Inspection/Service Report

Anonymized inspection example
Client and property details withheld

Report:	Inspection/Service Report
Inspection Date:	
Inspection Type:	Level II Inspection
Customer:	
Property:	
Systems Inspected:	5
Photos Included:	453
Deficiencies Noted:	Yes
Minimum Standards Met:	No
Suitable for Continued Use:	No

5.6. Lower Level Family Room – Screens and Glass Door Assemblies – Deficiencies Noted

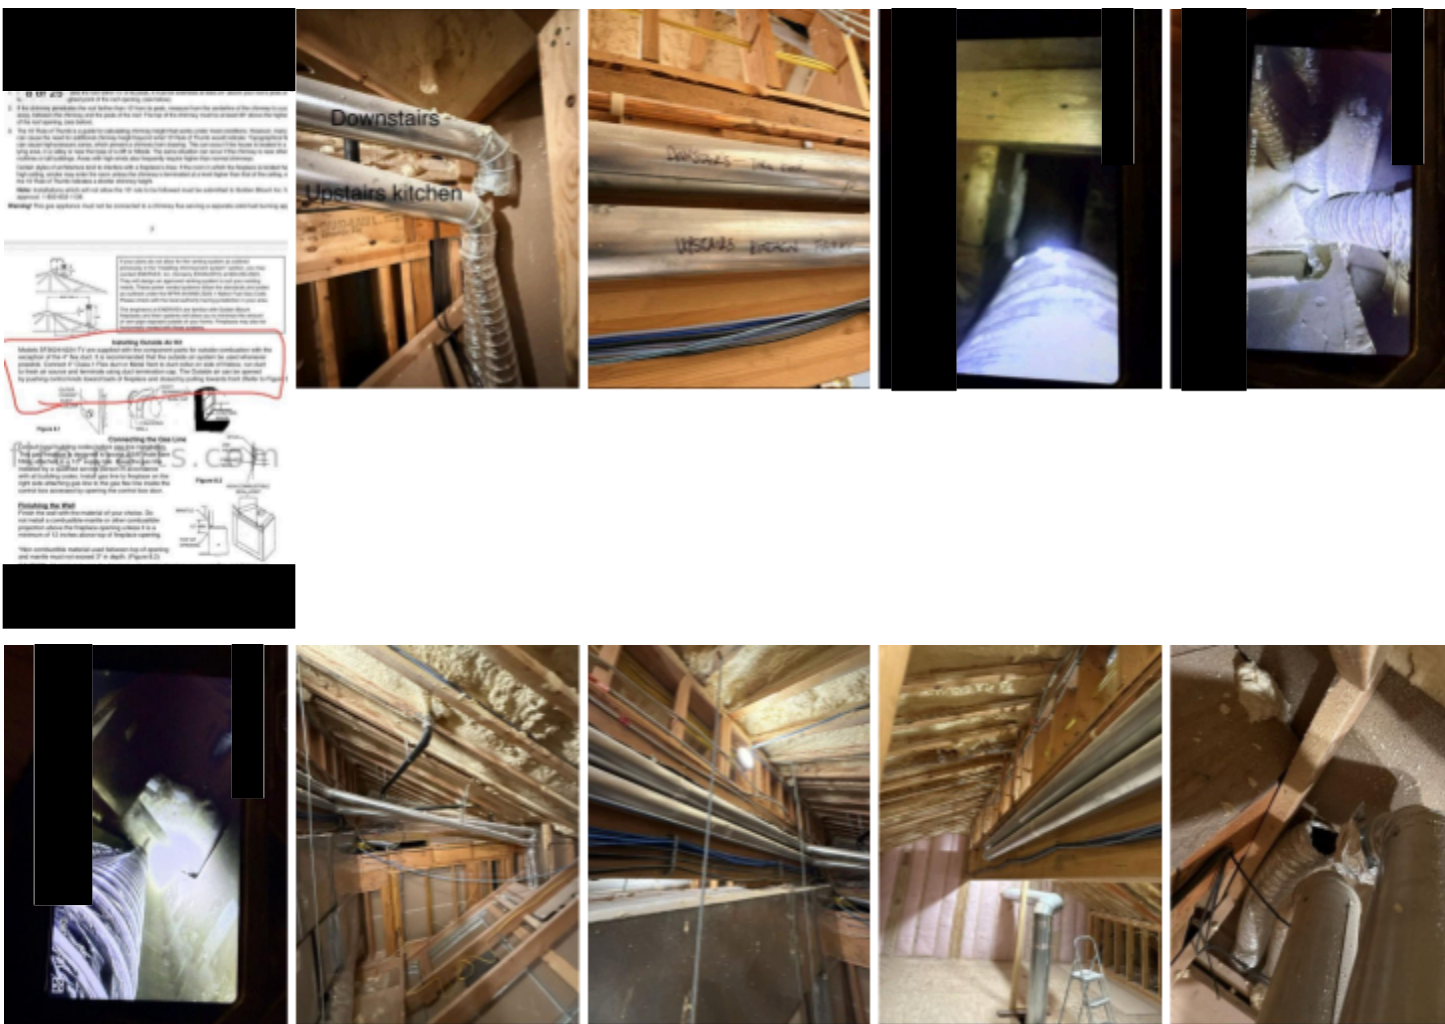
Description/Notes: The installed aftermarket door assembly could not be identified as a manufacturer-approved component for the SF-4224-TV. The available manufacturer documentation reviewed does not identify this door assembly as an approved accessory. The fireplace can be operated with the existing doors in place and open, which may affect the airflow characteristics of the listed appliance.

Deficiencies noted: Aftermarket/improper Components/materials.

5.19. Lower Level Family Room – Factory-Built Chimney/Vent Termination – **Deficiencies Noted**

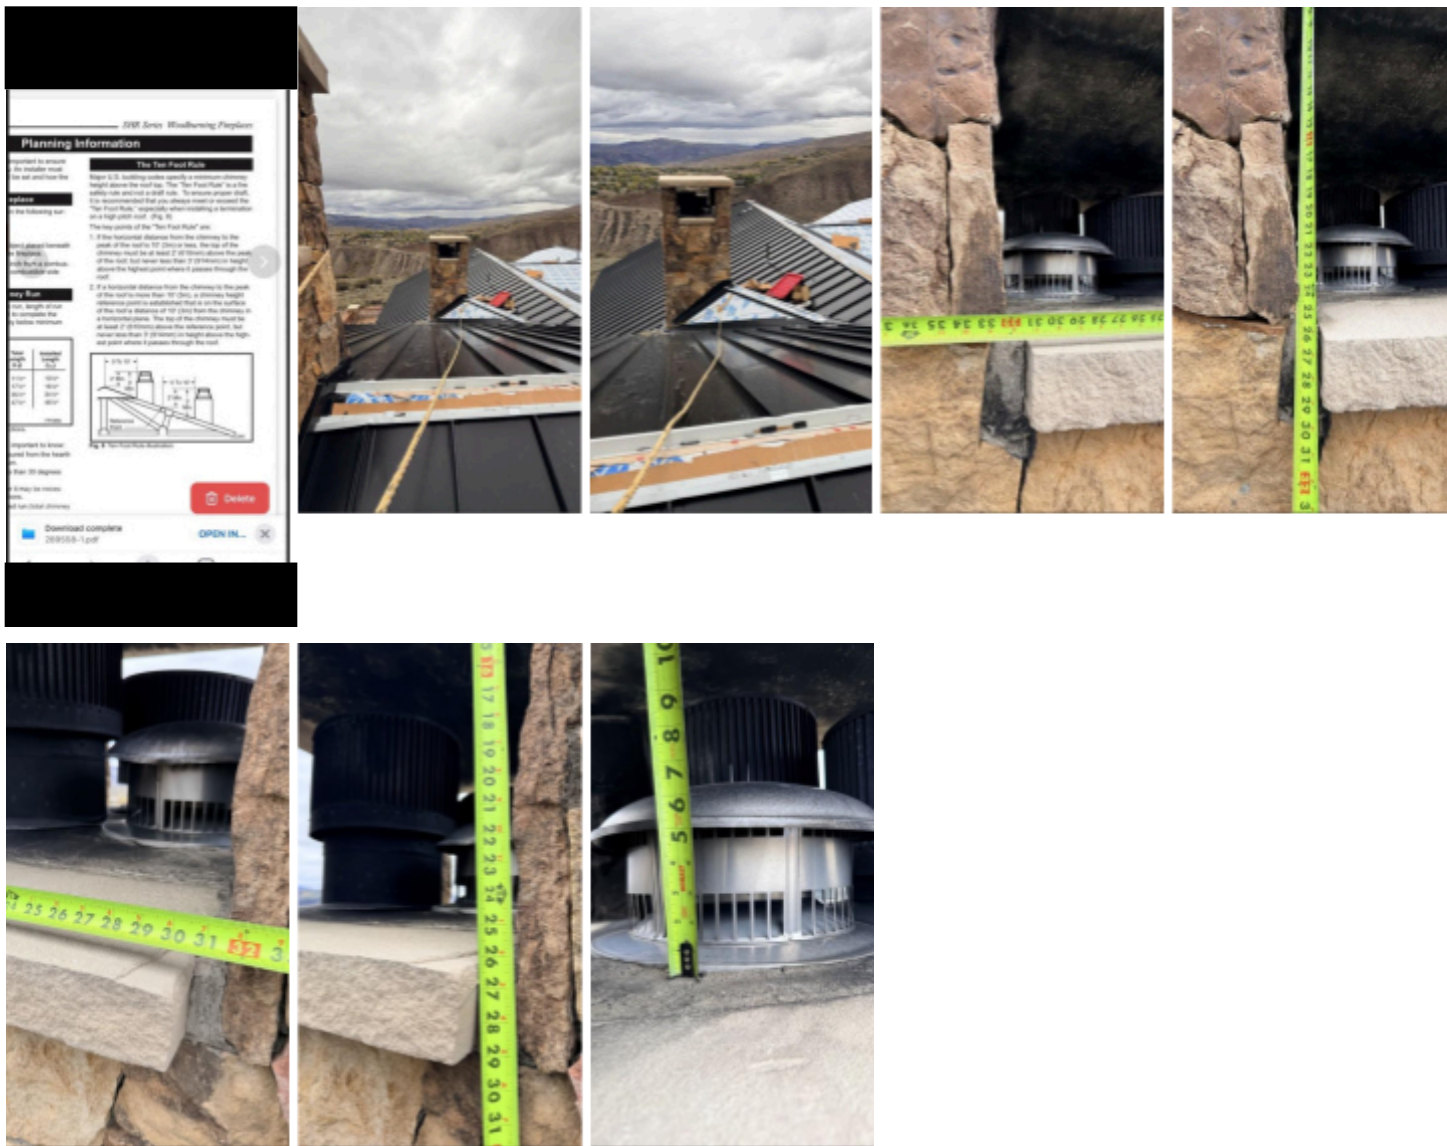
Description/Notes: The Golden Blount SF-4224-TV uses an 8-inch Type B gas vent. Golden Blount requires the chimney to meet its published minimum roof-height requirements and no manufacturer instruction was identified permitting those minimum requirements to be reduced because the termination is located within a chase, shroud, or architectural enclosure. The approved B-vent cap is recessed beneath/within the field-built stone crown rather than terminating in an unobstructed conventional configuration. The surrounding stone structure extends above the discharge area of the listed termination, and no documentation was identified establishing this recessed termination arrangement as approved.

The neighboring Majestic Type 11CF terminations are additionally subject to their manufacturer's requirement that chimney tops within the common enclosure be spaced at least 21 inches on center. The existing shared termination geometry does not provide that spacing.

Deficiencies noted: Height Requirements Not Met, Structure Taller Than the Chimney Termination, Termination Clearances Not Met.

5.20. Lower Level Family Room – Shrouds – **Deficiencies Noted**

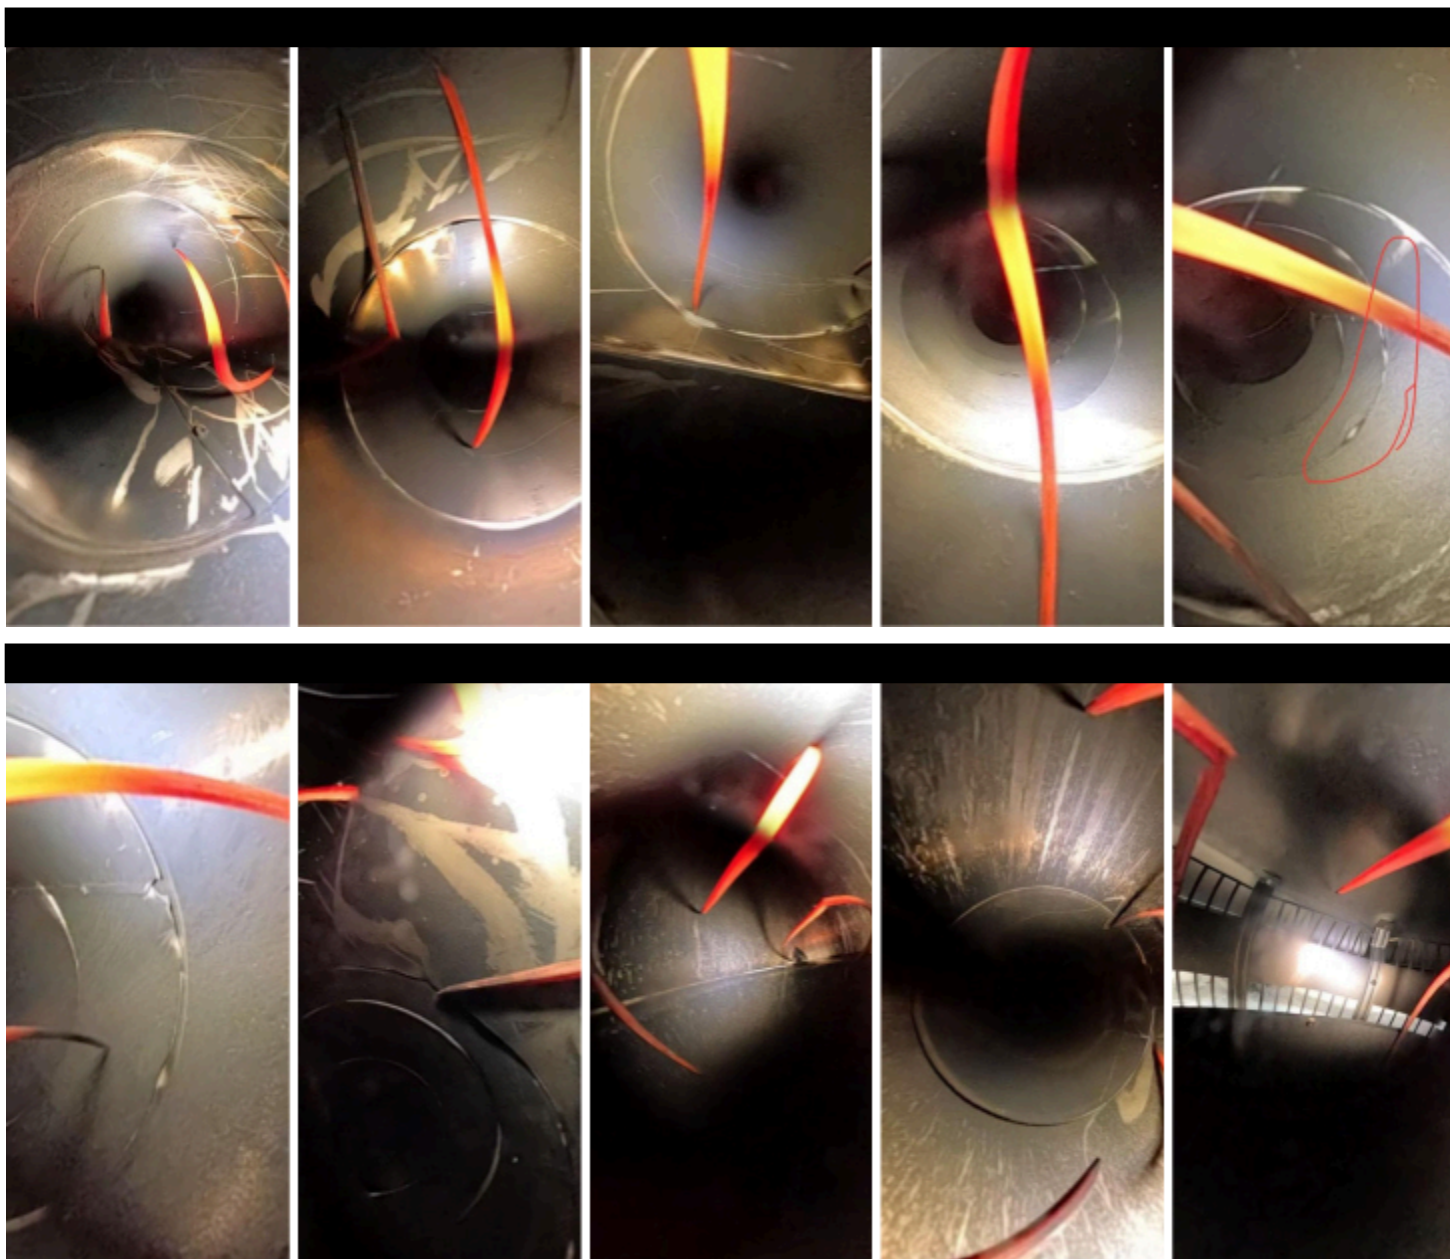
Description/Notes: The approved Type B gas-vent termination is located beneath and within a custom field-built stone enclosure/crown. Golden Blount's published installation instructions identify an 8-inch Type B gas vent or 8-inch Class-A chimney as approved venting methods but do not identify a listed decorative shroud or recessed stone termination configuration for this appliance. No documentation was identified approving the installed field-built enclosure.

Accordingly, the existing stone enclosure should not be assumed acceptable for continued use with the B-vent merely because the underlying vent and cap are listed components. A compliant repair would require an exposed approved termination arrangement or another documented manufacturer/engineered venting solution. Golden Blount specifically recognizes engineered alternative venting where the conventional venting arrangement cannot be achieved.

Deficiencies noted: Existing field-built shroud/termination configuration is not documented as approved for the installed vent system.

manufacturer requirements. Where the architecture prevents the standard venting arrangement, Golden Blount's current instructions recognize an engineered alternative venting approach rather than an improvised field modification.
